MODERNIZATION

COLONEL HOWARD NICHOLS SCHOOL
3401 RENEGADE AVE.
BAKERSFIELD, CA. 93306

BAKERSFIELD CITY SCHOOL DISTRICT

SITE PLAN

A
1.11

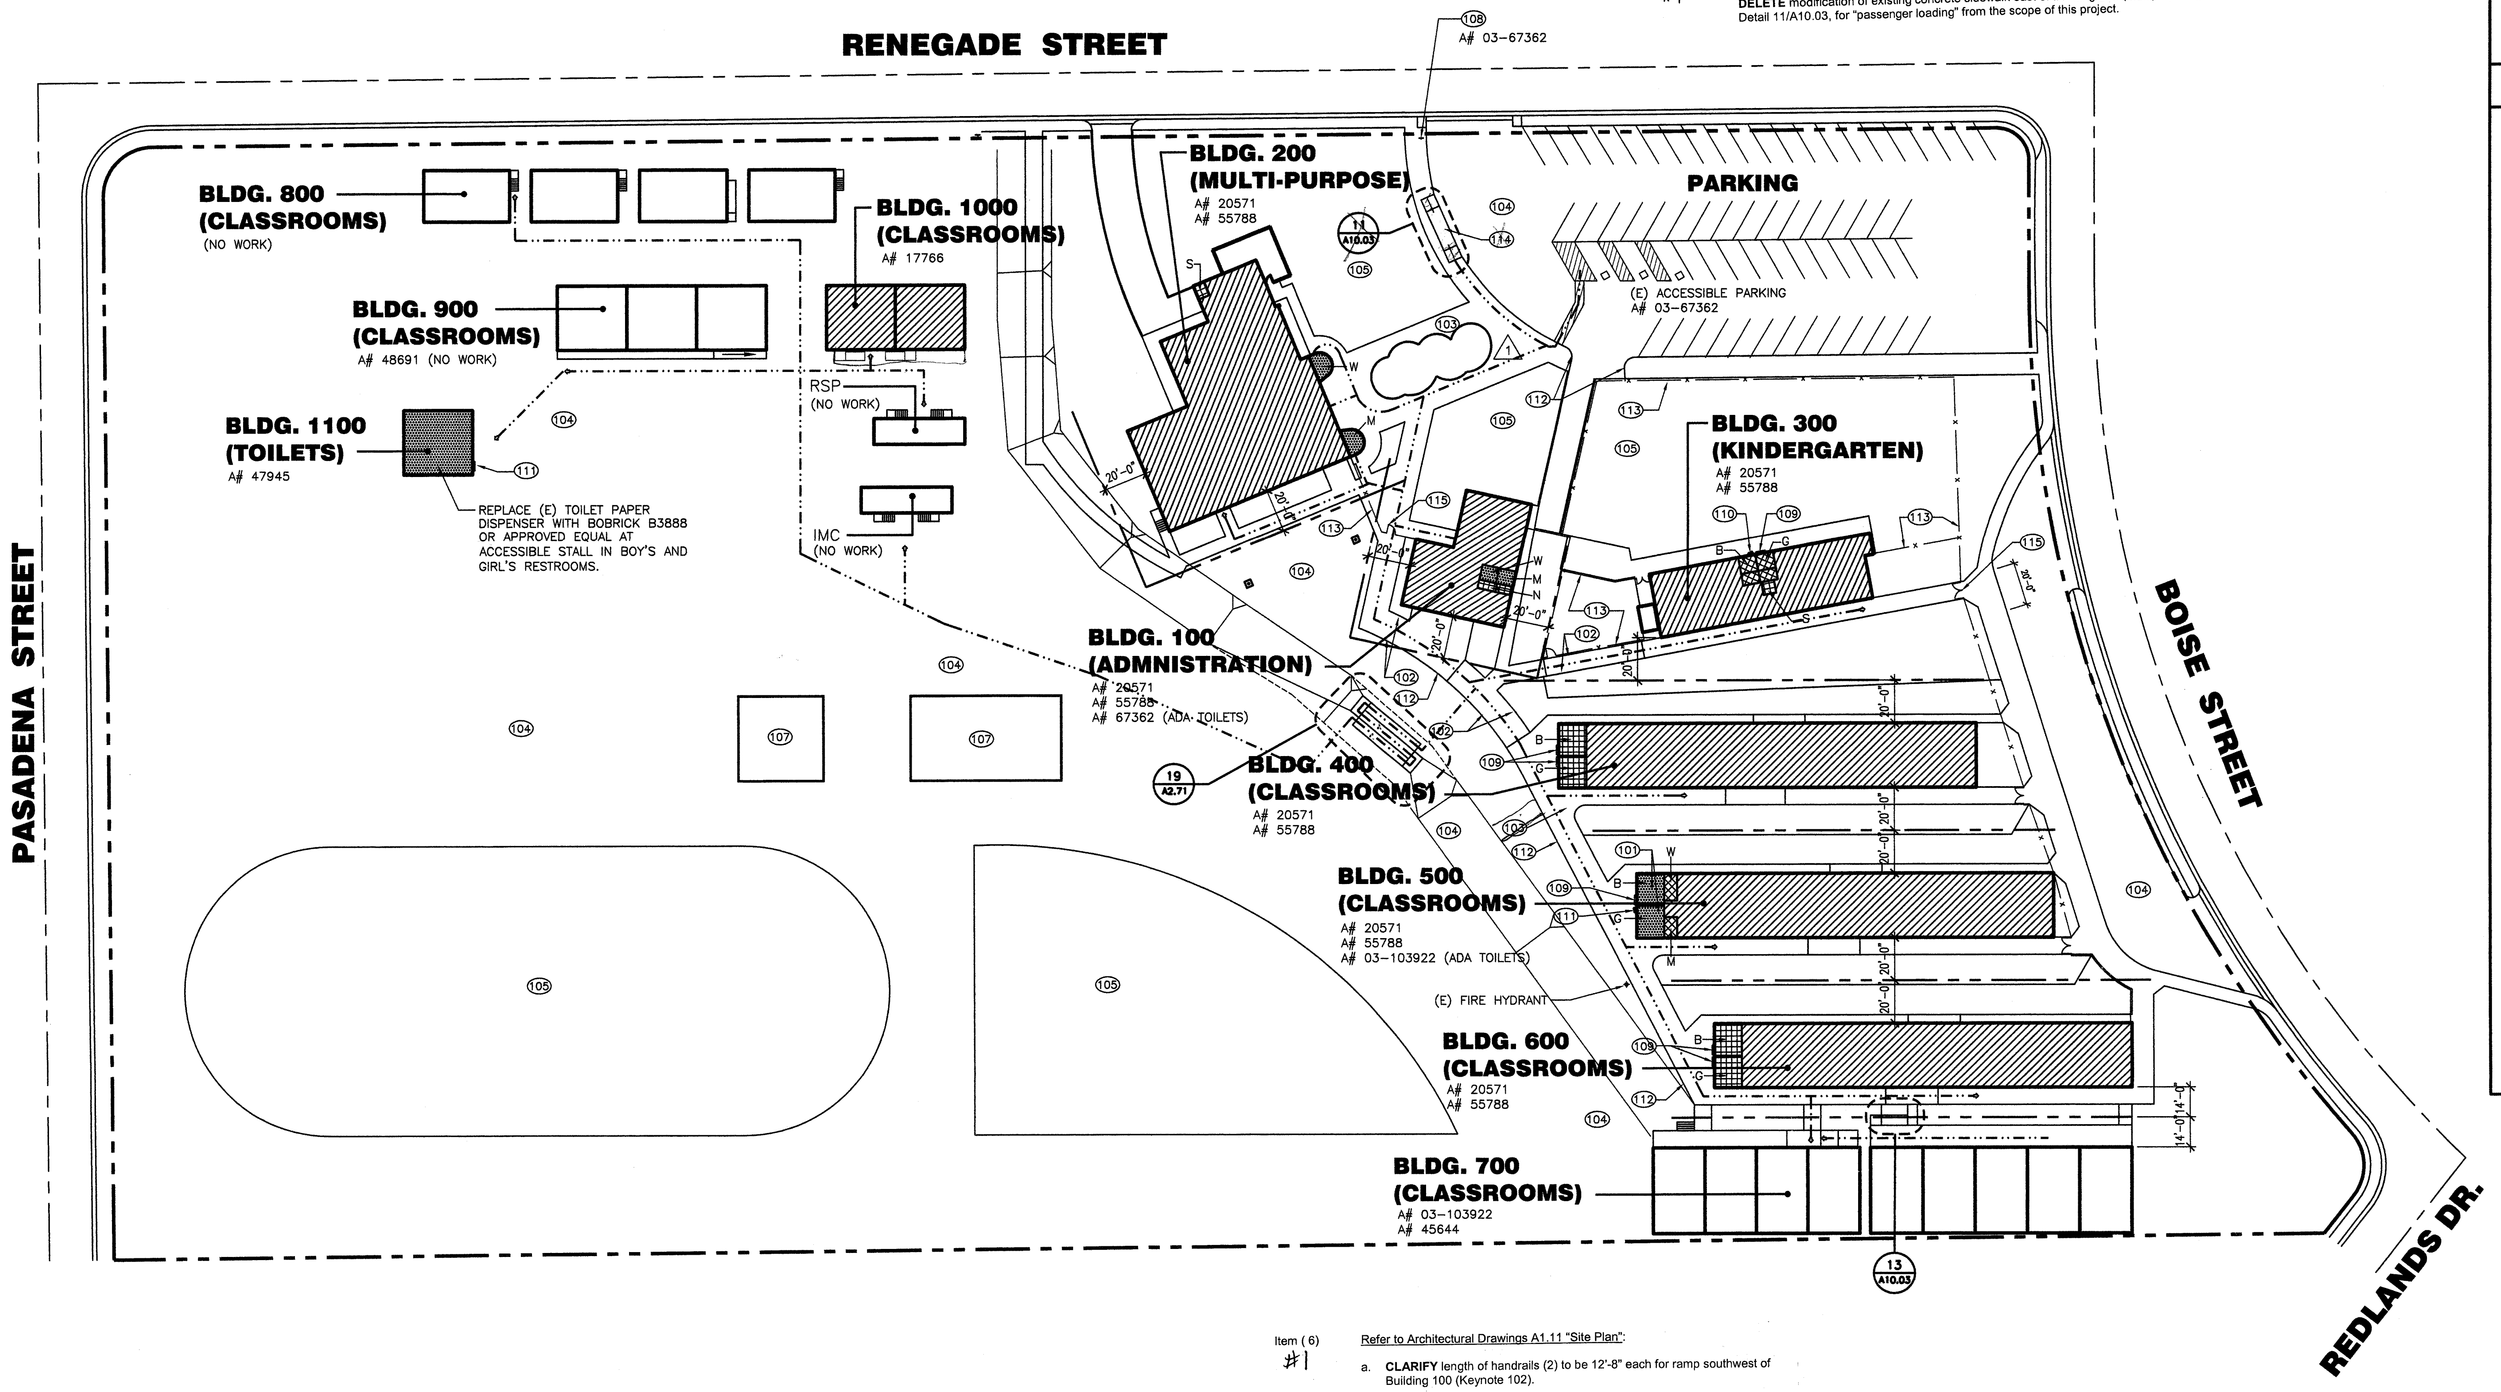
Refer to Architectural Drawings, Sheet A1.11 – Site Plan:

DELETE modification of existing concrete sidewalk east of Building 200 (Multipurpose). Detail 11/A10.03, for "passenger loading" from the scope of this project.

Refer to Architectural Drawings A1.11 "Site Plan":

a. **CLARIFY** length of handrails (2) to be 12'-8" each for ramp southwest of Building 100 (Keynote 102).

b. **CLARIFY** length of handrails (2) to be 47'-6" each for ramp west of Building 300 (Keynote 102).

c. **CLARIFY** length of handrails (2) to be 43'-6" each for ramp west of Building 400 (Keynote 102).

d. **PROVIDE** handrails per Detail 12/A10.01.

e. **ADD** exit hardware (Von Duprin 98/99 rim device) to ornamental gates west of Building 100 and east of Building 300 (Keynote 115).

f. **ADD** wire cloth (1 ½" x 1 ½" x 250" gauge) to each ornamental fence gate (2) and each adjacent side fencing (min. 2'-0"). Wire cloth shall be welded to fence and gates and painted to match existing fencing.
